Product Change Notice (PCN)

PCN Number: **PCN-0451141R-01**

Product(s) Affected: PJ-035D

PCB LAYOUT
TOP VIEW

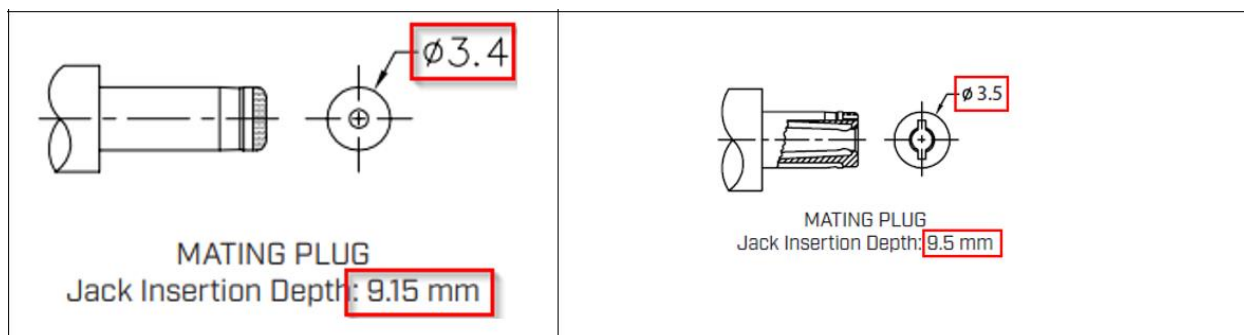
Description of Change: mechanical, and material differences as shown below:

DESCRIPTION: Mechanical, and Material Differences as Compared to CUI-000001

MATERIAL	PLATING
center pin	copper	nickel
terminal 1	brass	tin
terminal 2	copper alloy	tin
terminal 3	brass	tin
plastic	PBT

DESCRIPTION	MATERIAL	PLATING/COLOR
center pin	brass	nickel
terminal 1	brass	tin
terminal 2	bronze	tin
terminal 3	brass	tin
cover	PBT (UL94V-0)	black
housing	PBT (UL94V-0)	black
